## Groundwater Application Review Summary Form

Application # G- 18642

**To:** Kristopher Byrd, Well Construction and Compliance Section Manager  
**From:** Joel Jeffery, Well Construction Program Coordinator  
**Subject:** Review of Water Right Application G-18642  
**Date:** December 27, 2018

TO: Water Rights Section Date 12/21/2018  
 FROM: Groundwater Section Benjamin Scandella, Jen Woody  
 Reviewer's Name  
 SUBJECT: Application G-18642 Supersedes review of \_\_\_\_\_  
 Date of Review(s) \_\_\_\_\_

Figure 2. Water levels in Nearby Wells

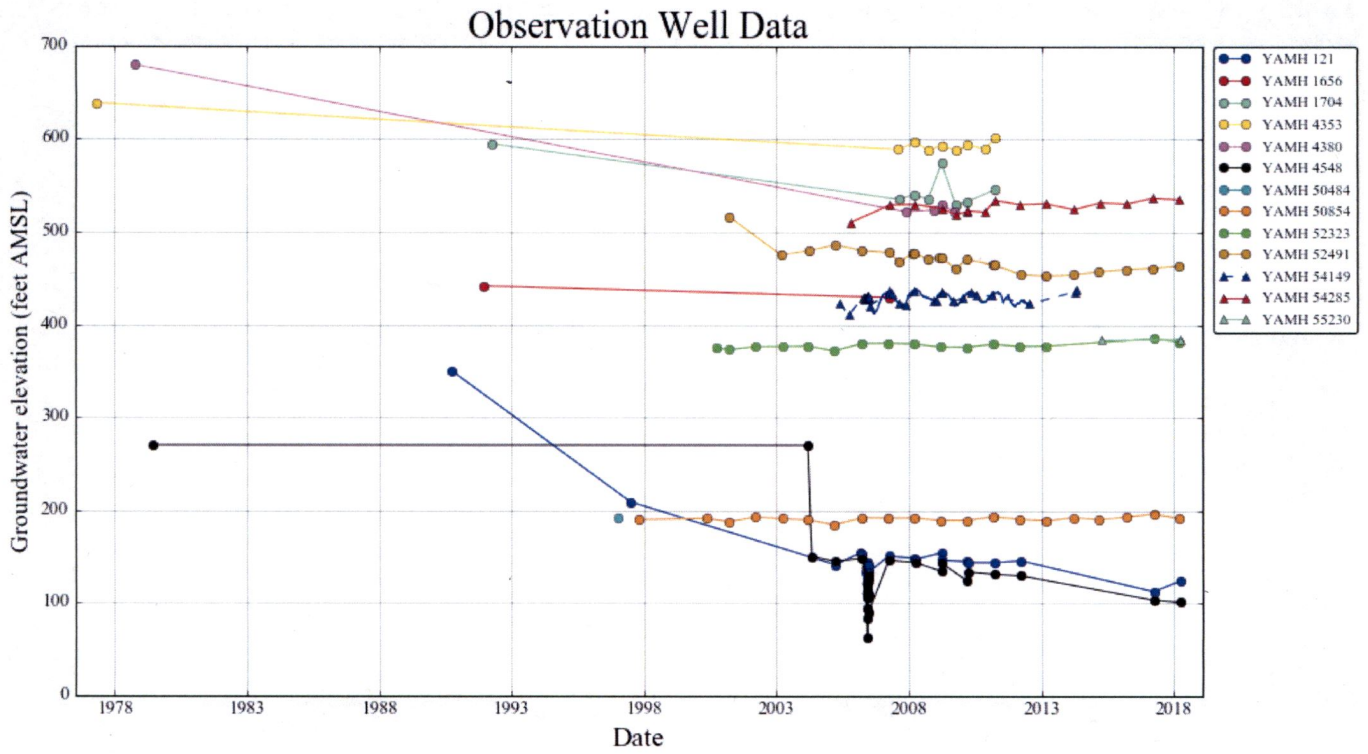
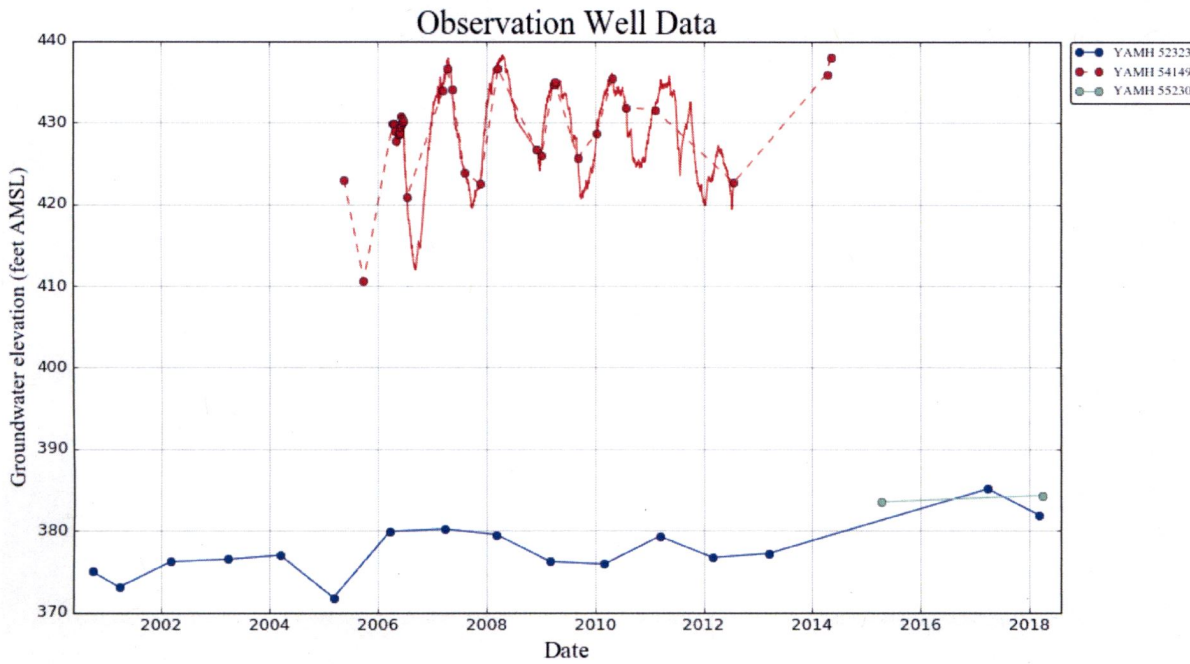
Water levels in wells located higher on the hill and to the West show relatively stable trends (see Figures 2 and 3), while wells located to the East (YAMH 50854, YAMH 4548, and YAMH 121) show evidence of long-term decline. YAMH 52323 (YAMH 52323) is among the former group and has shown relatively stable water levels for the entire period of record, from 2000-2018. Given the nearby location nearly identical proposed construction for the proposed well, it is expected to access the same water-bearing zones and show similar water levels to YAMH 52323. The two water-bearing zones in YAMH 52323 appear to be hydraulically connected, given their identical water levels in the well log, and they are likely also connected with water-bearing zones accessed by nearby wells (see Figures 1 and 4). However, the proposed magnitude of development is not expected to cause injurious well-to-well interference with neighbors or long-term water level decline. Water use and water level monitoring conditions are recommended to protect existing users.
